STAFF ANALYSIS

Case No.:	CZ-25-1247294	File ID #: 2024-1442	
Address:	1716 Pleasant Hill Trail, 7778, 7860, 7890, 7900, 7956 & 8024 Pleasant Hill Road	Commission District: 05	Super District: 07
Parcel ID(s):	16-197-03-006, 16-197-03-012, 16-219-01-005, 16-219-01-006, 16-220-01-004 16-220-01-007 & 16 220 01 009		
Request:	Major modification of Conditions #1 and #4 of CZ-18-22130 for the development of single-family detached dwellings within the RNC (Residential Neighborhood Conservation) Zoning District.		
Property Owner(s):	Hybrass Properties, LLC.		
Applicant/Agent:	Hybrass Properties, LLC. c/o Battle Law, P.C.		
Acreage:	95.52 acres		
Existing Land Use:	Single-family dwellings/vacant		
Surrounding Properties:	North: R-100, MU-1 East: RNC, R-85 South: R-85 West: R-85		
Comprehensive Plan:	Suburban (SUB)	Consistent	Inconsistent X

Staff Recommendation: TWO-CYCLE DEFERRAL

CONCEPT PLAN
FOR
PLEASANT HILL

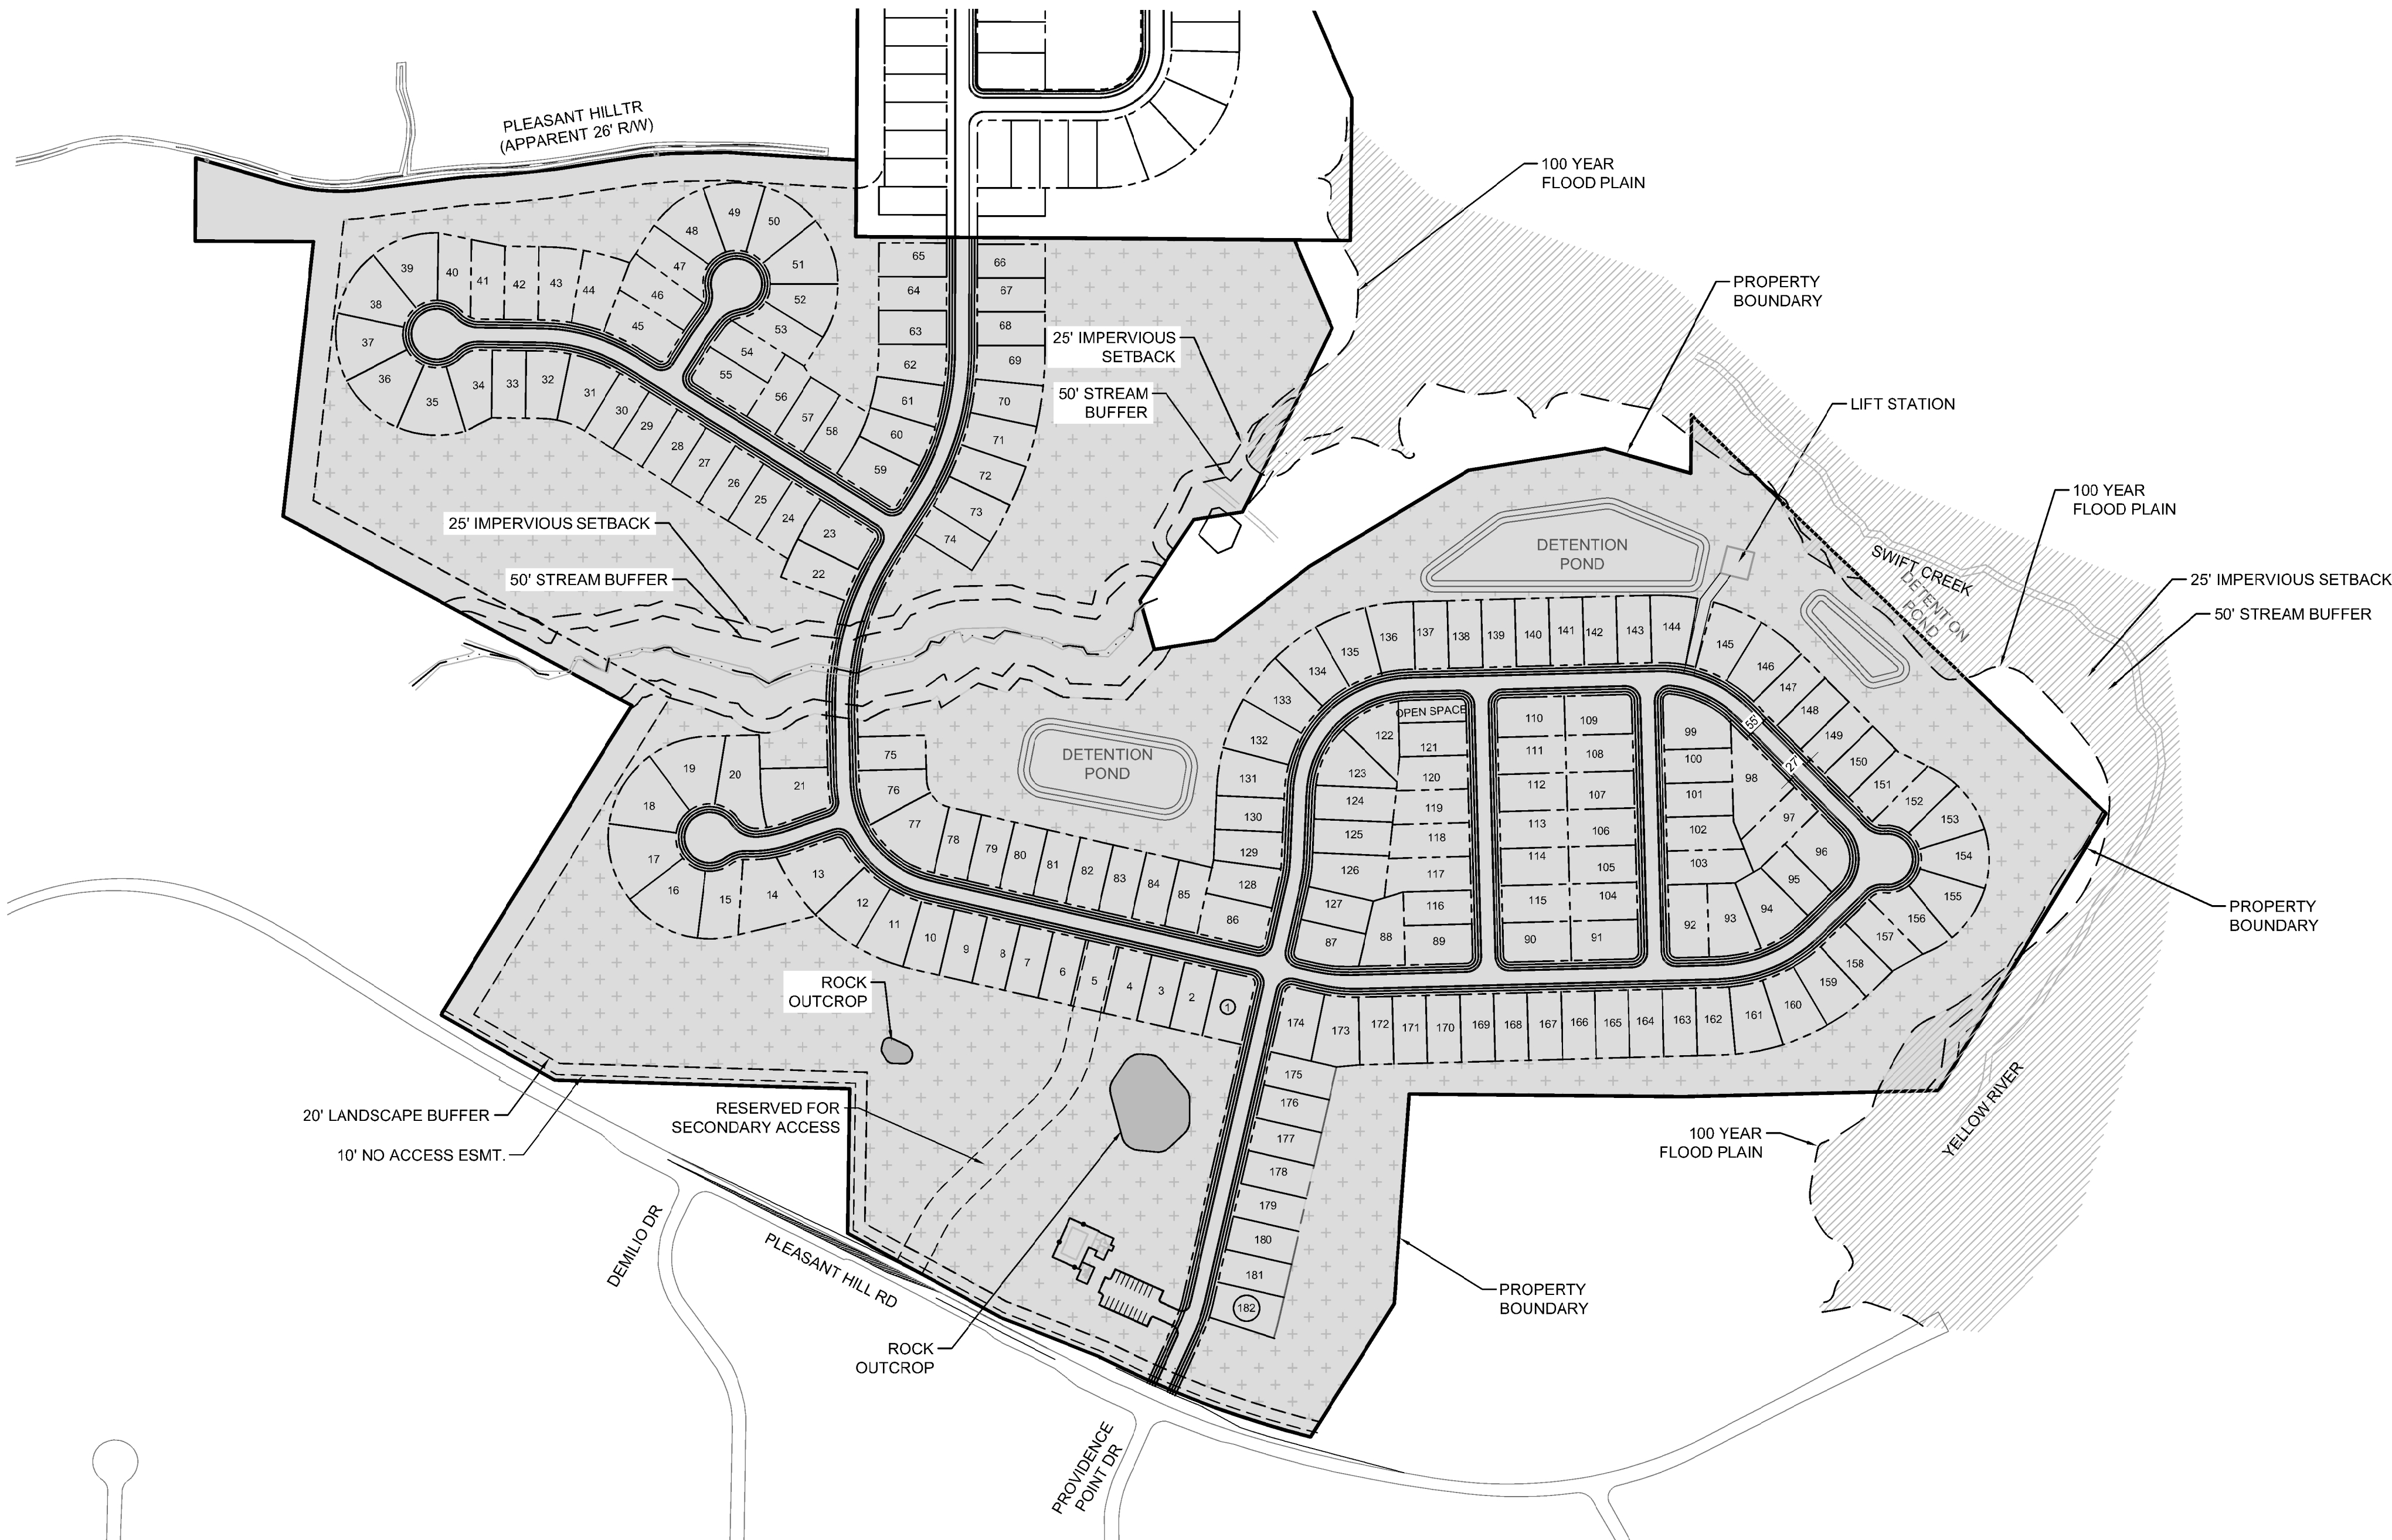
A modification of Condition #4 would relocate the originally proposed access points along Pleasant Hill Road to accommodate topography. One of the access points would connect to a proposed subdivision to the north of the development site; notably, however, Current Planning has yet to have received a Sketch Plat application for such a subdivision. An additional access point would be provided only for emergency vehicles. Per the current site plan, only (1) of the three (3) access points would be for regular traffic off of Pleasant Hill Road, which has raised concerns from Staff as well as the surrounding community.

While the reduction of units allows for the potential preservation of greenspace that is encouraged with RNC developments (see Section 2.10.2. of the *Zoning Ordinance*), there are still potential issues with topography that may affect the configuration and/or potential lot yield with the development. Namely, the new site plan does not appear to prove compliance with the minimum greenspace requirement as defined per Section 2.10.5. of the *Zoning Ordinance*. A minimum of 30 percent of the total site area shall be dedicated to greenspace, which may not consist of the following features (per Section 2.10.5.(B)):

The submitted site plan shows a development that appears to have extreme slopes throughout, as well as having state waters/stream buffers. Meeting this greenspace requirement could pose a challenge for development and could affect lot yield.

As a result of meetings with Current Planning Staff, the applicant has requested a deferral of the proposal to revise their site plan and provide additional information. In coordination with the applicant's request, the Planning and Sustainability Department recommends a *Two-Cycle Deferral* to address the above issues.
